TE10 TABLET ELEVATOR - DESIGN UPGRADES

2021-06-03

Attachment Method

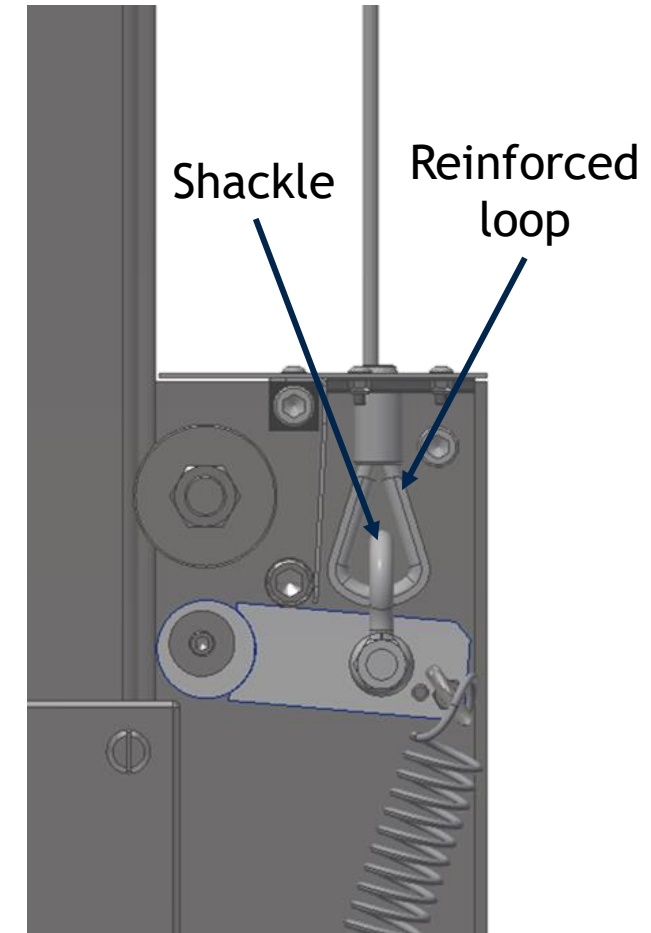
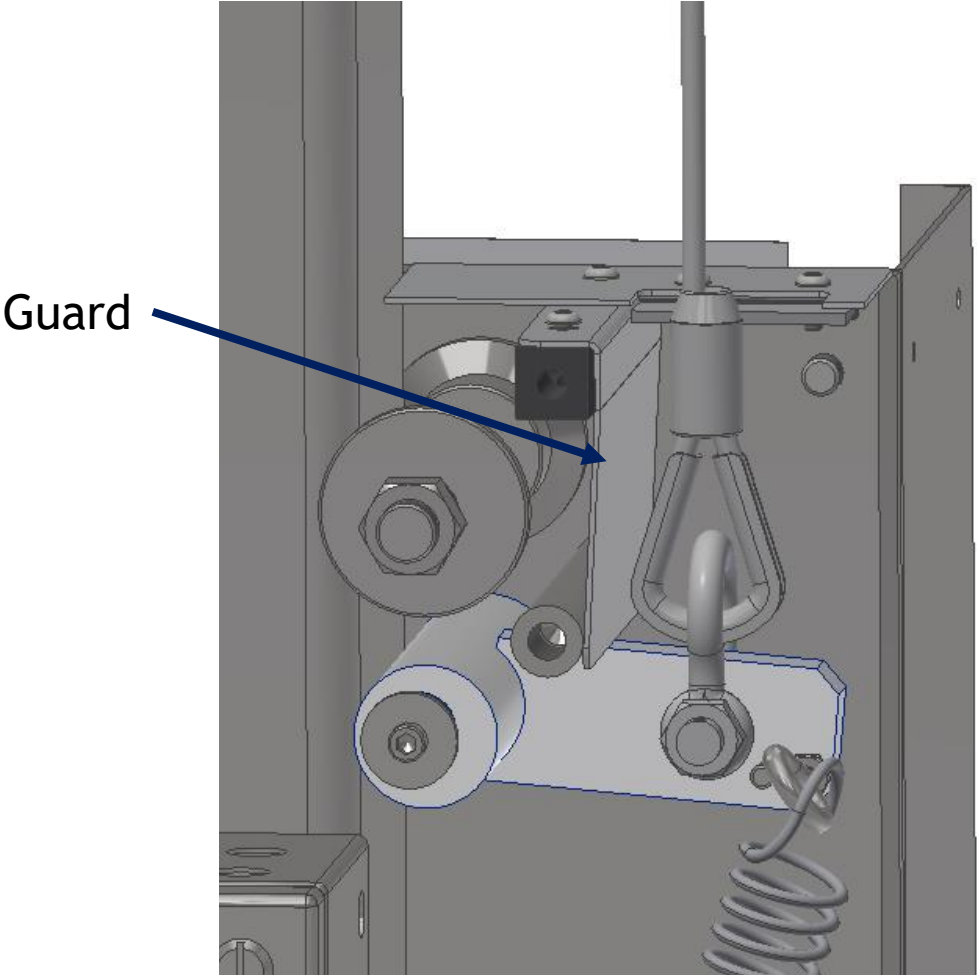
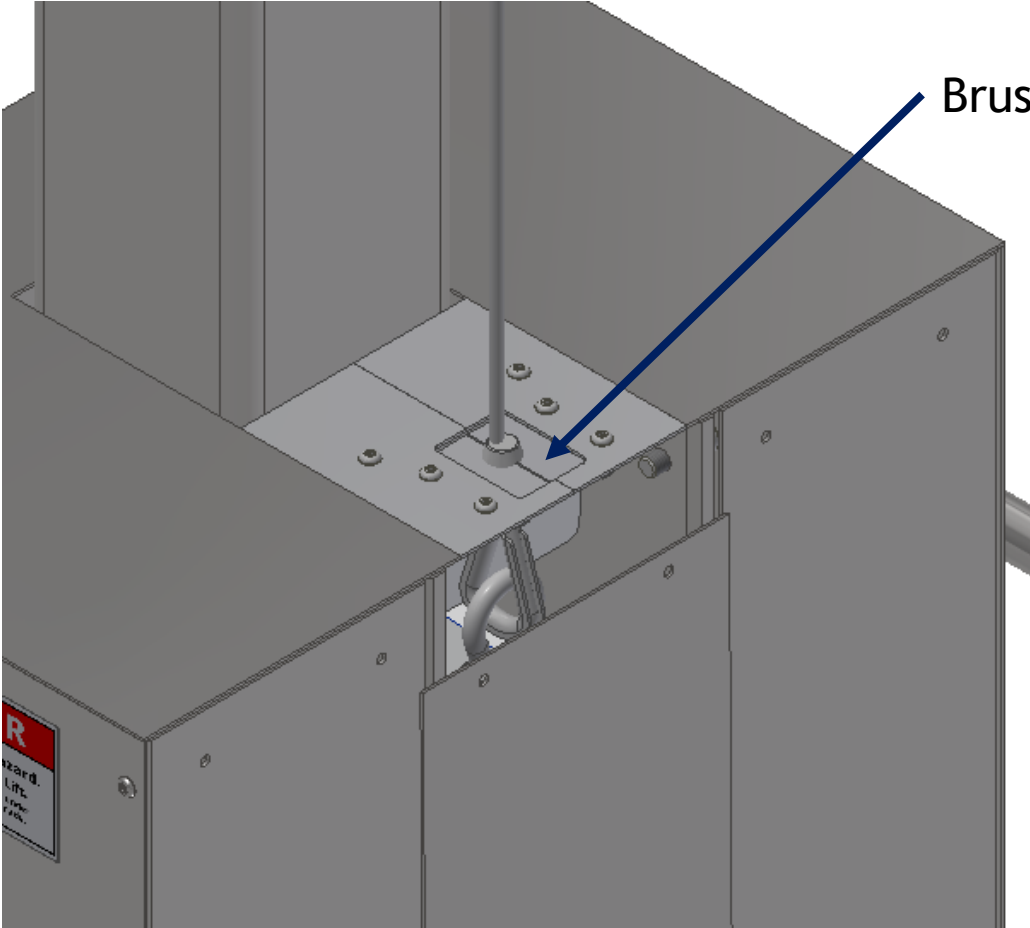
- New attachment method using a cable with a built-in reinforced loop and a shackle
- A new guard and brushes added due to movement of the shackle when brake engages/disengages

Guard and Brushes

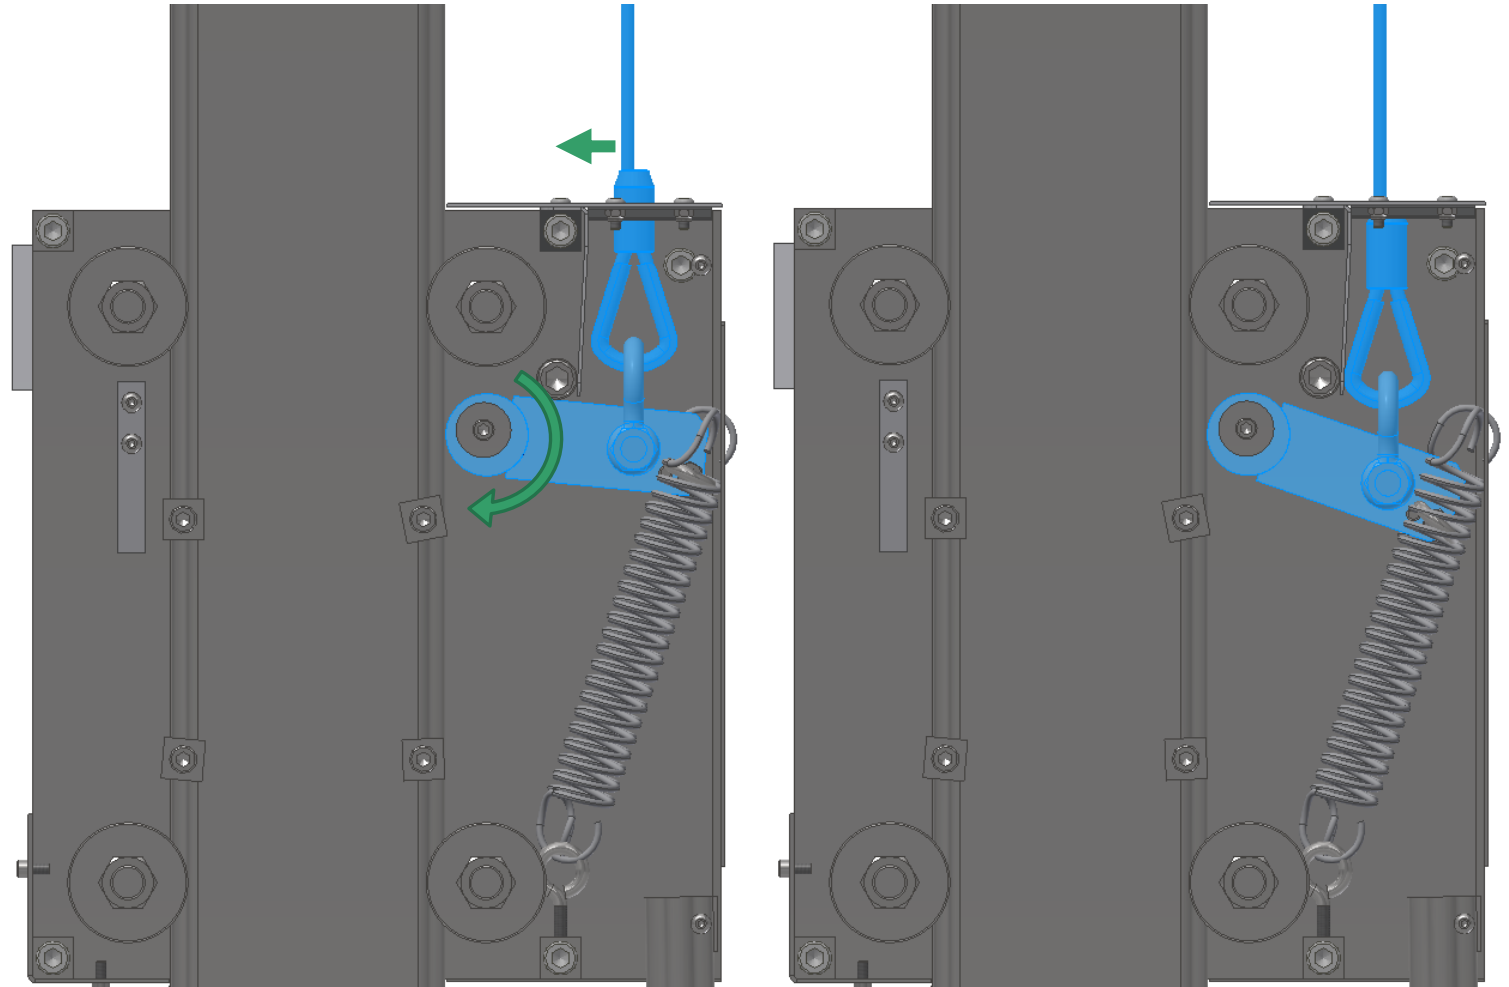
- When brake is engaged, it rotates, causing cable to move laterally
- Guard prevents cable from hitting the square post, preventing wear

Guard and Brushes

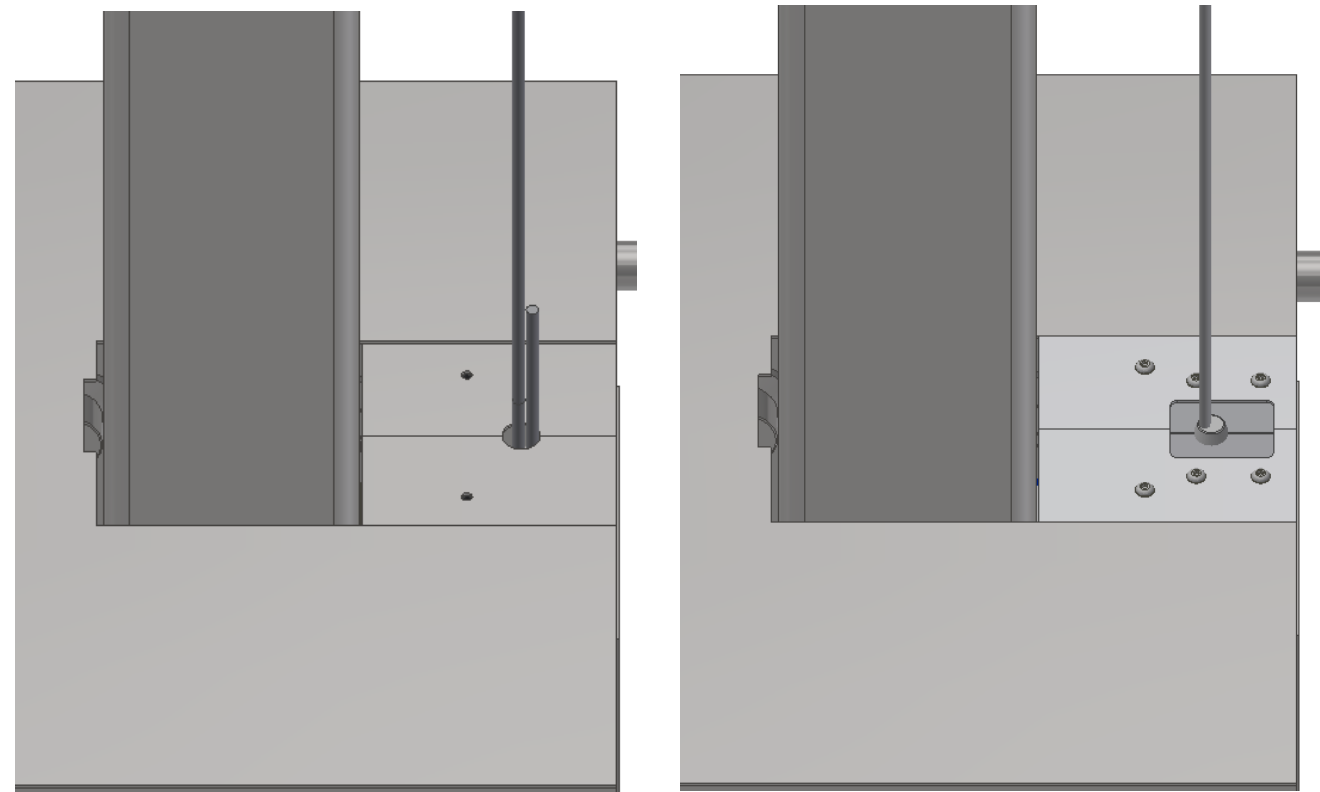
- The previous design included metal sheets with a round hole for the cable. Lateral movement in the cable would cause the cable to rub against this hole
- The brushes allow lateral movement in the cable without wear

Safety Signs

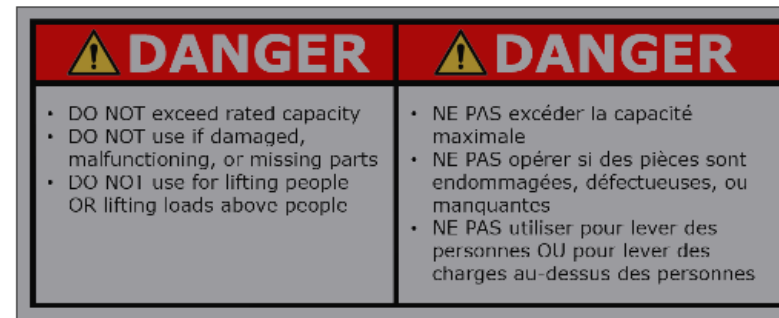
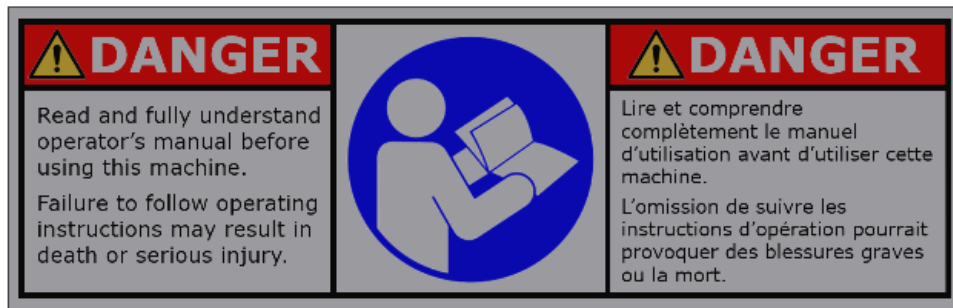
- New safety signs according to the standard: ISO 2864-2: 2004

Kits For New Assembly

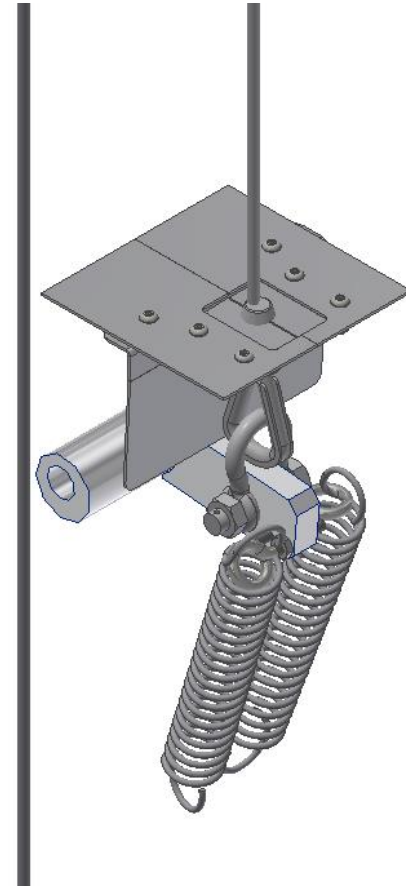
- TE10-AS0007-00 retrofit kit for new brake and cable assembly
 - Refer to assembly drawing for installation instructions
 - Parts included:
 - Brake
 - Brush kit
 - Cable guard
 - Cable
 - Shackle
 - Springs
 - Eye bolt for spring mounting
 - Safety signs
